April 9, 2026

ADDENDUM NO. 7TO THE CONTRACT DOCUMENTS
FOR THE CONSTRUCTION OF**NEW ARFF/SRE BUILDING – PHASE 2**
AT
ITHACA TOMPKINS INTERNATIONAL AIRPORT
ITHACA, NY

FAA AIP NO.: 3-36-0047-xx-2026

C2 CONCRETE APRON @ OVERHEAD DOORS
SCALE: NOT TO SCALE

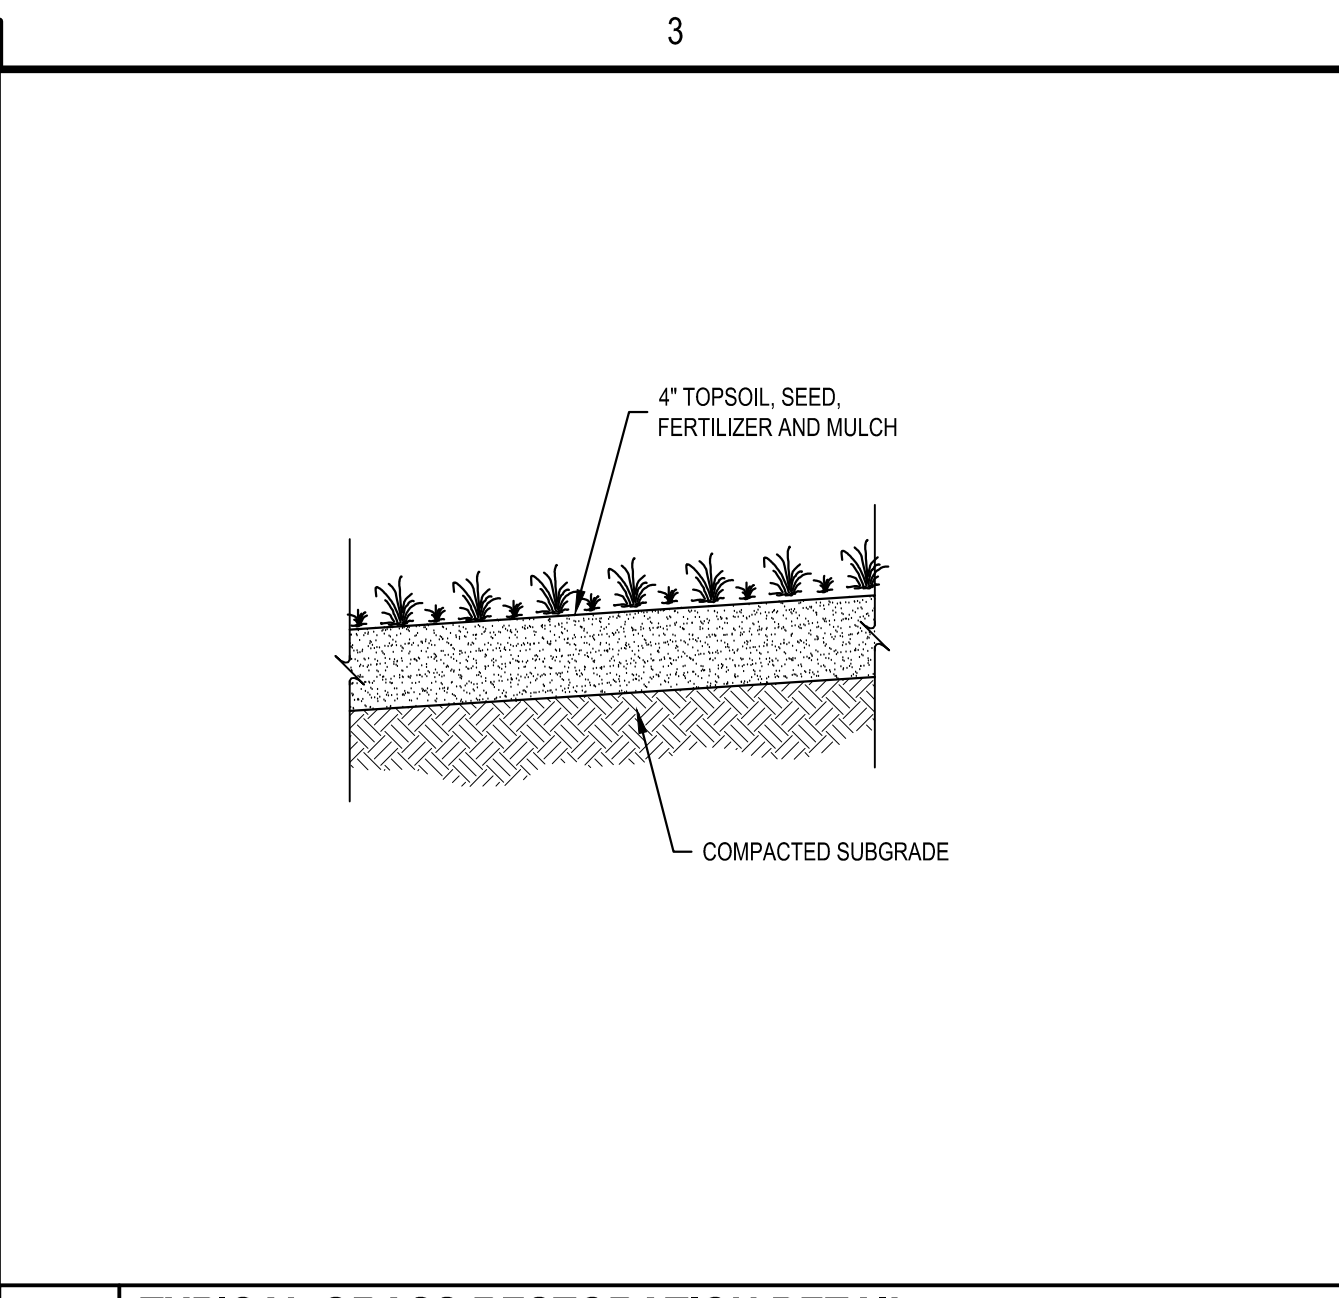
7. **Q53: Question: CONCRETE PAVING / APRONS** - Spec Section 321313 Concrete Paving indicates different types of steel reinforcement. Drawing C-501 detail C2 only indicates Fiber Reinforcement and detail B1 indicates Dowels into floor slab. For clarification, in the Concrete Paving / Aprons located at the Overhead Doors, reinforcement is only Fiber and Dowels into Floor slab? Please advise.

- A. See Sheet C-501 Revision 1 issued under this Addendum. Reinforcement in the Concrete Paving / Aprons located at the Overhead Doors shall be #5 BARS @ 12" O.C.E.W. and shall be doweled into the building floor slab as shown on detail B1/Sheet C-501.
